Office Action Summary

10/828,503

DETAILED ACTION

Figure A

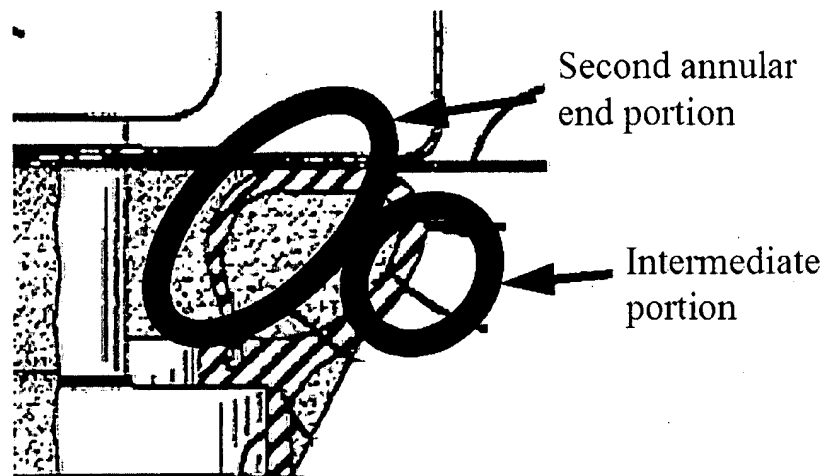
a. A column hole cover 4 interposed between a circumferential portion of an aperture of a column hole formed at an instrument panel 1 for insertion of a steering column 16 therethrough and a steering gear box 2 capable of being displaced in a predetermined direction, the column hole cover comprising: a cylindrical main body 5 extended in the predetermined direction, the main body including a first annular end portion 8 directly or indirectly fixed to the steering gear box, a second annular end portion (see Figure A of this Action), and an intermediate portion (see Figure A of this Action) between the first and second end portions, the second end portion including an annular seal, the intermediate portion including a expandable/contractible portion capable of being elastically expanded or contracted in the predetermined direction, wherein, irrespective of the displacement of the steering gear box, the annular seal is maintained in an

elastic pressure contact against the circumferential portion of the aperture of the instrument panel by a reaction force of the compressed expandable/contractible portion (col 1, lin 39-50) (claim 1.)

8. Applicant's arguments filed 7 December 2006 have been fully considered but they are not persuasive. Applicant argues that the second annular seal is on the second end portion, which is not shown by the reference numeral cited by the Examiner. In the previous Action, the Examiner referred to the nearest numerals, which made the record unclear. The present Action has clarified the rejection (see Figure A above), which the Examiner maintains as proper.
